Model : P75/55IMx

Intel Merom CPU + PM965 + ICH8-M Chipset
Santa Rosa plantfrom (No supported AMT)

Revision History		
	08/2006	Initial Rev.RA
	09/2006	Rev.A1
	11/2006	Rev.A2
	01/2007	Rev.B
	03/2007	Rev.C

UNIWILL COMPUTER CORP.			
File		P75/55IMx	
Size	Document Number	INDEX	
	3581	Rev C	
Date	Tuesday, March 13, 2007	Sheet	1 of 37

USB PORT CONN

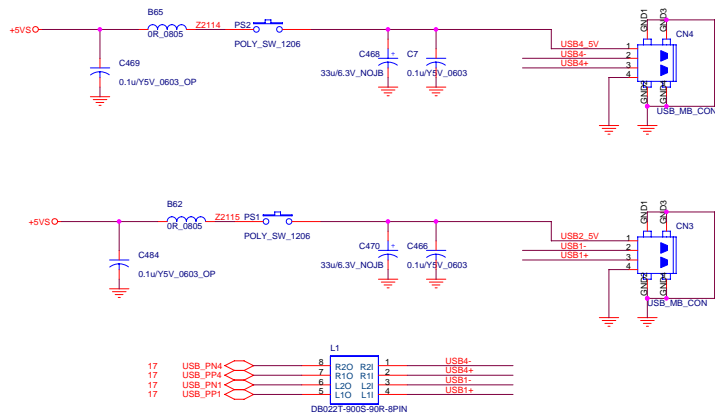
USB CONN change from 3 ports to 2 ports @ REVA2
One USB ports W/I charger remove to daughter board and add eSATA port@ REVA2
